NRDC Comments on the 2016 Title 24 Building Energy Standards – 45-Day Language
Docket #15-BSTD-01
March 30, 2015

On behalf of our 1.4 million members and online activists, 250,000 of whom are in California, the Natural Resources Defense Council respectfully submits the following comments on the 45-day language for the 2016 Title 24 Building Energy Standards (“the Code”) proposed in February 2015. NRDC appreciates the opportunity to comment.

Figure 3: Energy Savings and Incremental Cost Analysis for assemblies with U=0.046 and below.⁷

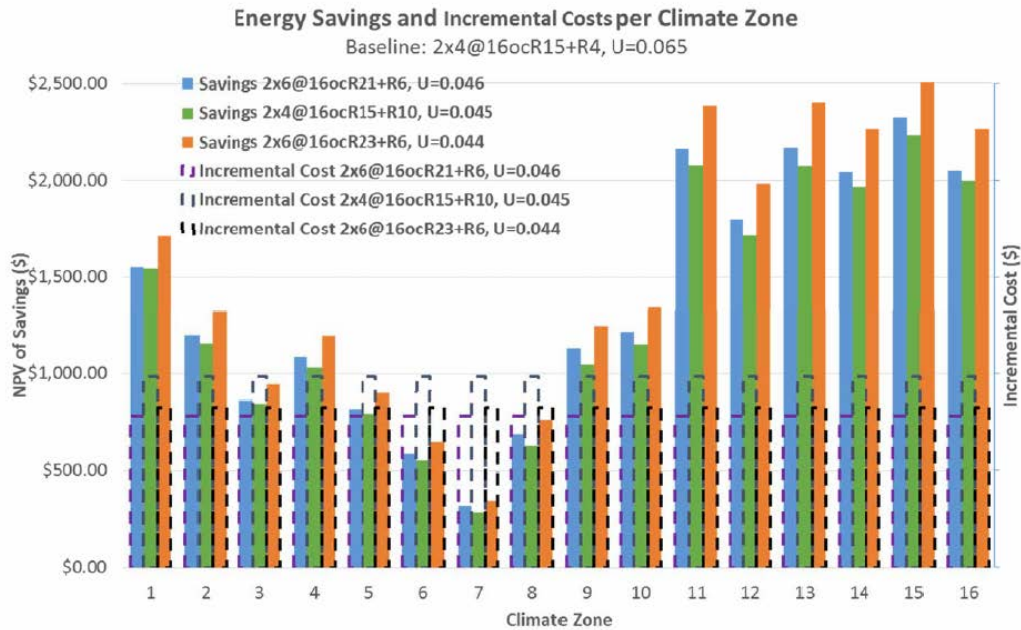
The CEC proposes increasing the wood-frame wall U-factor to U=0.051 in all climate zones. However, the CASE report found that a U-factor of U=0.044 would be cost-effective in almost all climate zone (except climate zones 6-8). The CASE report recommended a U-factor of U=0.046 which corresponded to the highest level evaluated using 2x4 studs. We recommend that the CEC modify the proposed standards to require a U=0.044. Stopping short of the highest levels found to be cost-effective is likely to impede efforts to reach zero net energy by 2020. Setting levels at the highest level that are cost-effective will allow builders to become more familiar with construction techniques to reach these levels, potentially leading to innovation and further cost-effective savings in the future. Alternatively, failing to adopt the highest cost-effective levels now could limit future savings opportunities.

Additionally, the CEC should require a U-factor of U=0.044 in all climate zones, even though the CASE analysis did not show it to be cost-effective in climate zones 6-8. There are several reasons for this. First, the CASE report does not take into account any reduced equipment costs from smaller equipment enabled by the reduced heating and cooling loads that come with increased envelope insulation. Therefore, the CASE report most likely overestimates the cost of reaching a given U-factor in all climate zones. If these costs were taken into account it is probable that a U=0.044 would be cost-effective in all climate zones. Secondly, the CEC would most likely find a U=0.044 to be cost-effective in all climate zones even without taking into account reduced equipment costs, if evaluated compared to historic practice (rather than the most recent standard), as the Warren-Alquist Act requires. Finally, the Warren-Alquist Act also requires that the standards be cost-effective in total, not that every proposed change be cost-effective. The increased cost of a U=0.044 in climate zones 6 through 8 will likely be offset by savings from other measures, resulting in standards that are cost-effective overall.

At a minimum, the CEC should adopt the highest cost-effective levels as the basis for the performance path. We understand that it may be too late to implement different requirements in the prescriptive and performance paths this cycle, but think the CEC should consider this approach for future code cycles. While there may be concerns with setting prescriptive levels that essentially require specific construction techniques, the performance path allows the builder the flexibility to trade these off with other measures in whatever way they see fit as long as the energy performance requirements are met. Given this flexibility, the performance path should not stop short of the highest levels found to be cost-effective.

Figure 3: Comparison of Gas and Electric TDV values in Climate Zone 12¹⁶

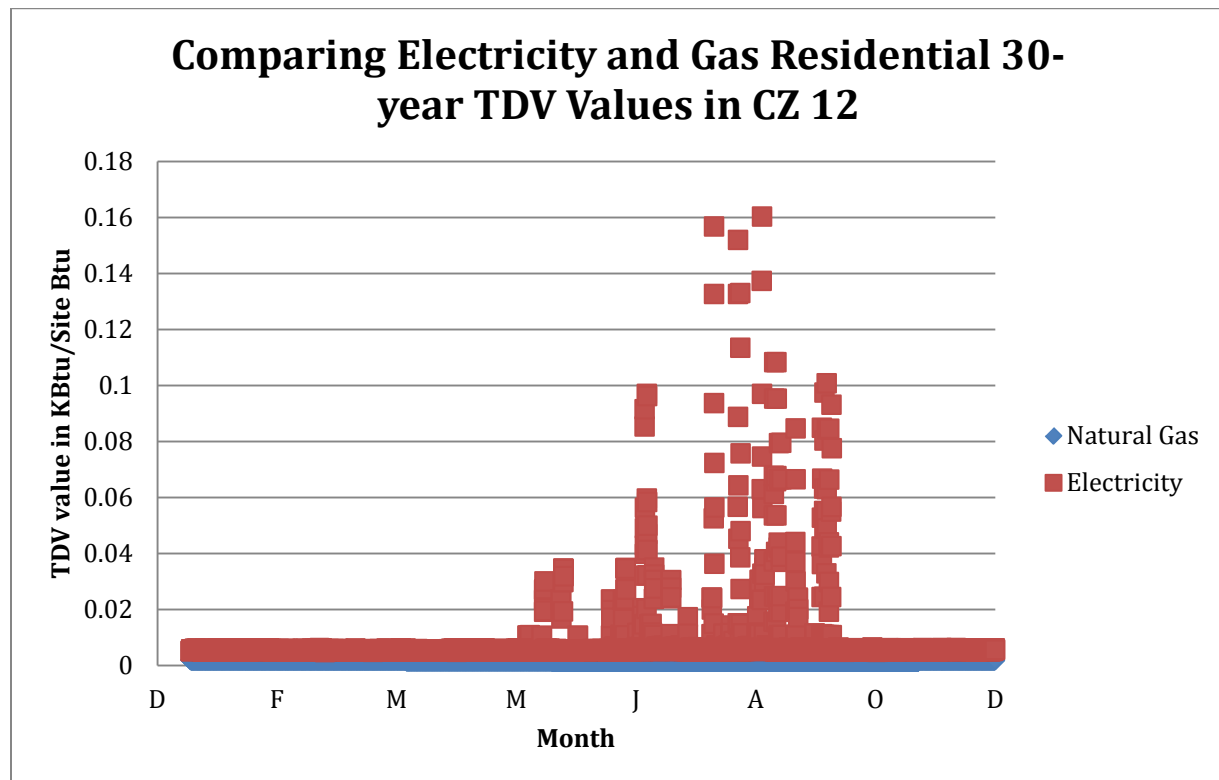
The below graph shows the TDV values of electricity and gas for climate zone 12, adjusted to a common denominator of site Btu. The TDV value of electricity is roughly three times that of gas in off-peak hours and over 100 times that of gas in the highest peak hour. This is questionable, and may have material impacts. For example, it has the effect of highly favoring the use of gas over electricity, especially for space and water heating equipment, where gas equipment is used in the reference design. This wasn't a material issue in the past due to the clear superiority of gas for heating. However, there are now updated heat pumps, and a growing capability for grid-interactive water heaters to dynamically avoid high-cost periods in real time. These developments offer a potentially significant benefit which requires further consideration.

This difference could set up a self-inconsistent process, in which the TDV values cause homebuilders to prefer end-use gas to electricity, and result in a shortfall in meeting 2050 emissions goals. The consequence of this shortfall will be a large increase in the cost of carbon, which will affect the cost of gas a lot more than the cost of electricity (since by 2030 or later, the electric system will be based mostly on renewables or very-high efficiency gas generation).

Figure 4: Average Annual Electric TDV Values for CZ12 show the constant RPS adder.¹⁷

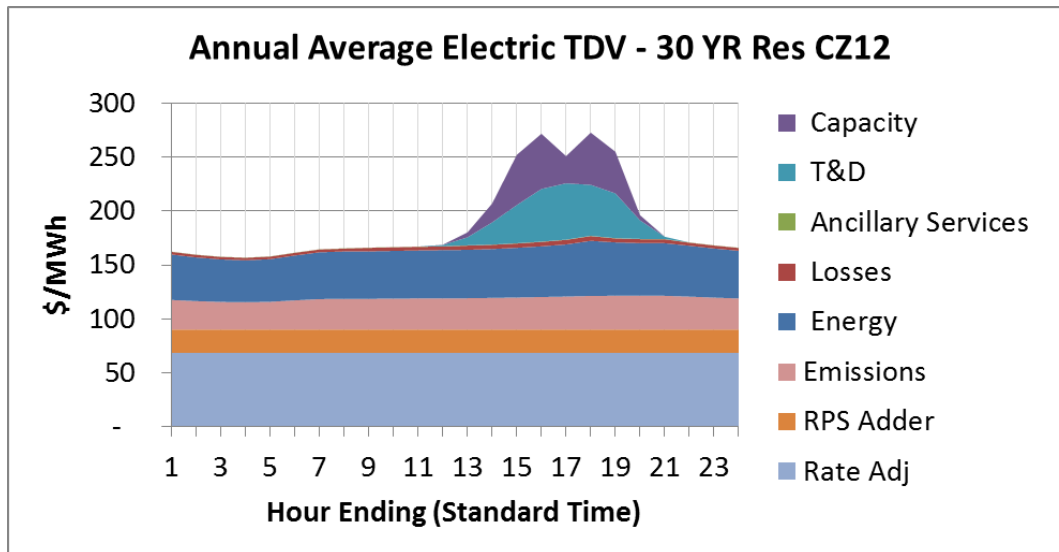
One reason for the large difference in current gas and electric TDV values is the method for valuing renewables in the electricity TDV calculations. Under the current methodology, renewables are considered as an additional avoided cost, calculated by multiplying the percentage RPS by the MWh avoided and the \$/MWh factor for renewables (See Figure 4). This means that the higher the assumed penetration of renewables, the higher the value of avoided electricity and the higher the cost of electricity compared to gas. This is counter to the result that would lead to the best societal outcome: the more renewables are used to generate electricity for new homes, the more TDV encourages gas rather than the renewables-heavy electric option. Clearly, the outcome should be the reverse: the more renewables used to generate electricity, the more favored electricity should be as a fuel choice.

We urge the CEC to address this issue in the next TDV update. In doing so, CEC should use best available estimates for renewable penetration and efficiency. We think that the current estimates used for the 2016 TDV are conservative and that other assumptions would be more appropriate.
